ENVIRONMENTAL REVIEW TEAM REPORT

SEYMOUR MEADOWS SUBDIVISION SEYMOUR, CONNECTICUT

MAY 1979

FIGURE I. SIMPLIFIED SITE PLAN

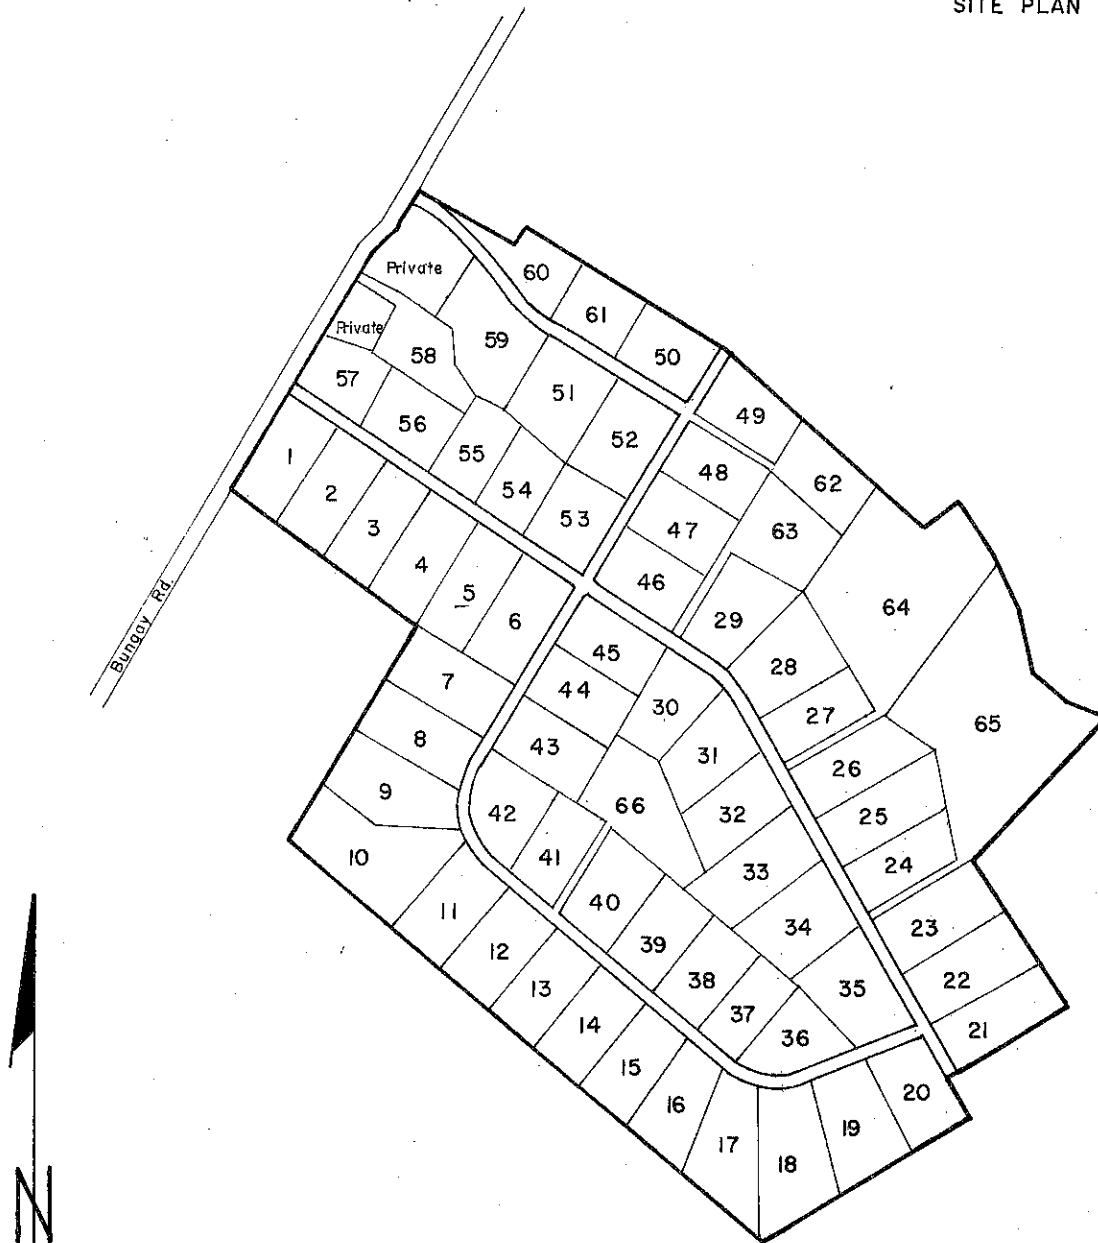
The subdivision plan calls for 66 lots and the construction of several interior roads (see Figure 1). Proposed lots are predominantly one acre in size and, at this writing, are to be served by on-site wells and septic systems. The developer of the project has indicated, however, an interest in extending public water supply to the site if suitable arrangements can be made.

- The proposed inland wetland road and driveway crossings, if properly designed and carefully constructed, should not have a significant adverse impact. The alternative "esplanade" interior road proposal, mentioned informally by the developer the day of the ERT field review, is considered preferable to the present Nickel Mine Drive proposal. The storm drainage system for the roads throughout the subdivision should consist of slotted pipes or have the joints cracked to prevent frost heaving.

The proposed road and driveway crossings of inland wetlands, if properly designed and carefully constructed, should not have a significant adverse impact on the wetland areas. The alternative "esplanade" interior road proposal, mentioned informally by the developer at the ERT field review, is considered preferable to the present Nickel Mine Drive proposal as this would eliminate direct disturbance of the wetland area in the northwestern corner of the parcel.

The storm drainage system for the roads throughout the subdivision should consist of slotted pipe or have the joints cracked to pick up ground water. This practice will help to prevent the build up of hydrostatic pressure under the streets which can add to frost heaving.

It would be advisable to prepare a master plan of the proposed subdivision which illustrates the locations of all the wells in relation to the locations of all the septic systems. This plan could be reviewed by the local department of health and would help to ensure the proper location of all wells relative to septic system leaching fields.

FIGURE 2.
TOPOGRAPHIC MAP

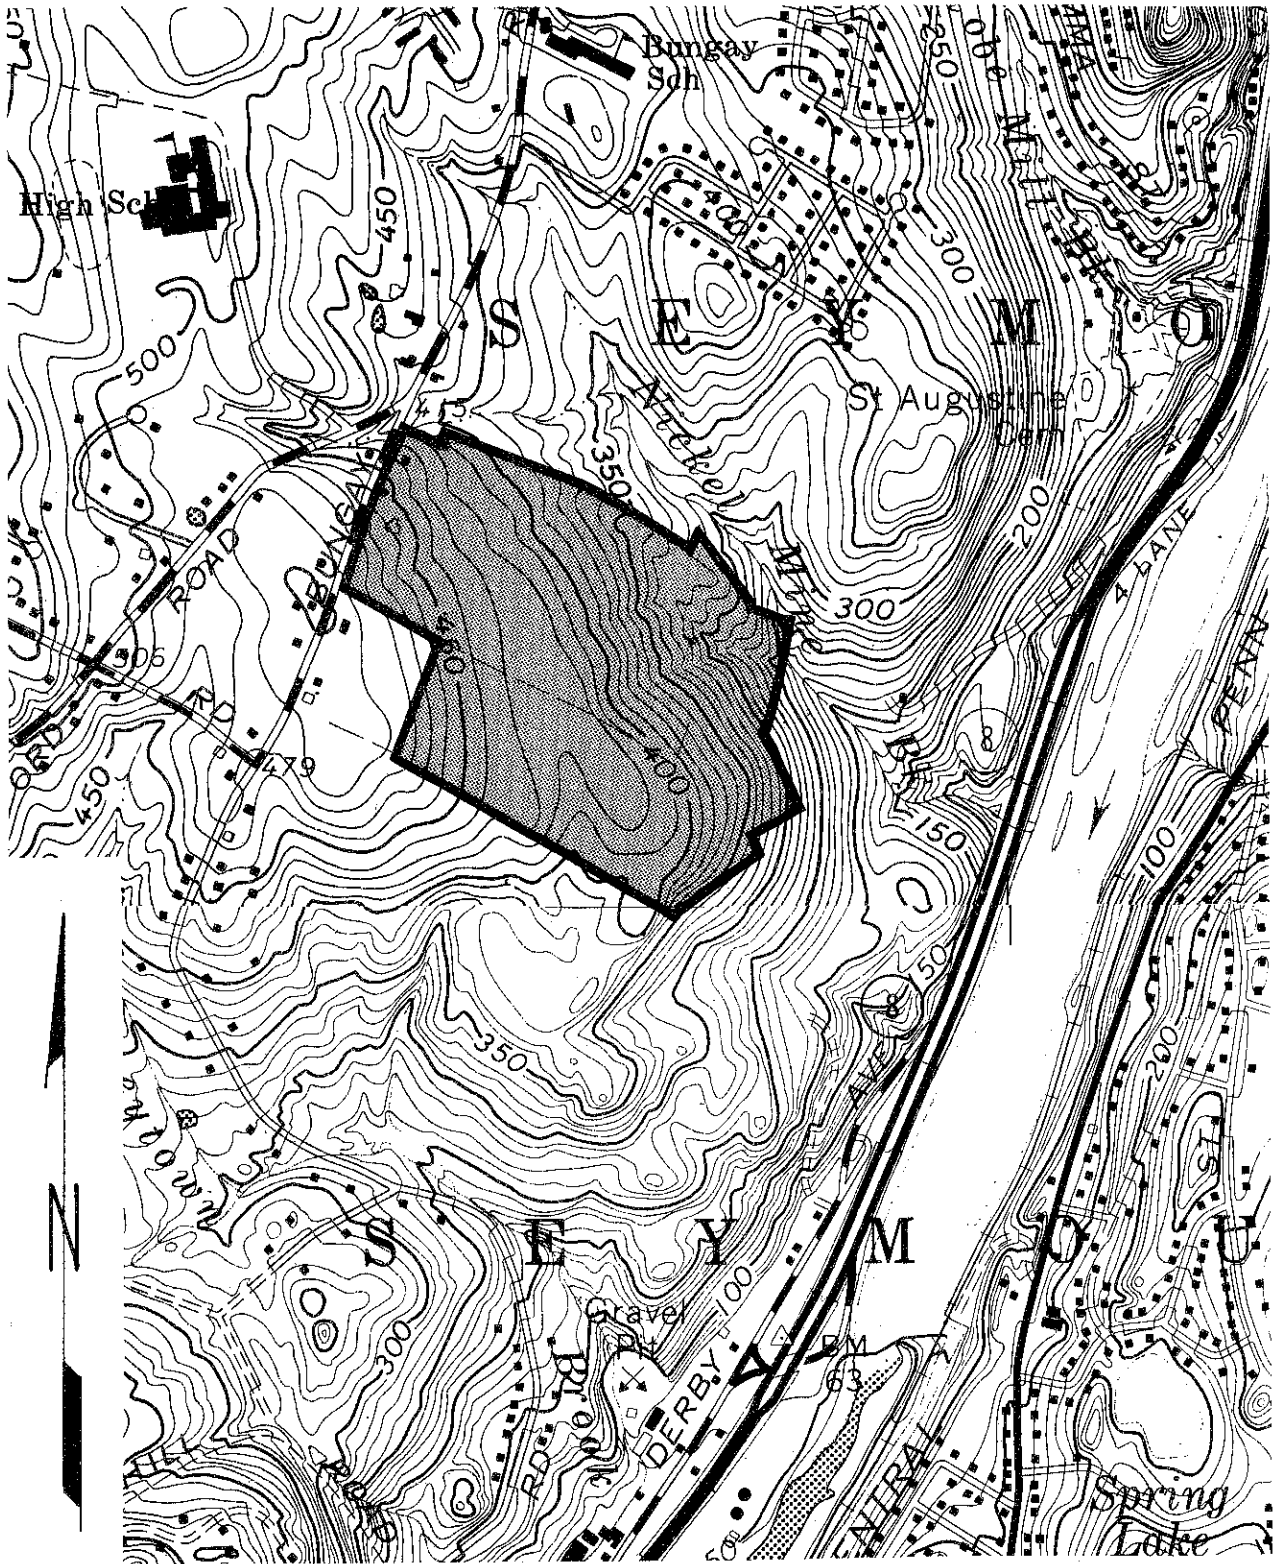
Topography of the site varies from gently rolling on the western two-thirds of the property to moderately-steeply sloping on the eastern third of the land (see Figure 2). The property slopes from west to east resulting in an aesthetic viewline to the east.
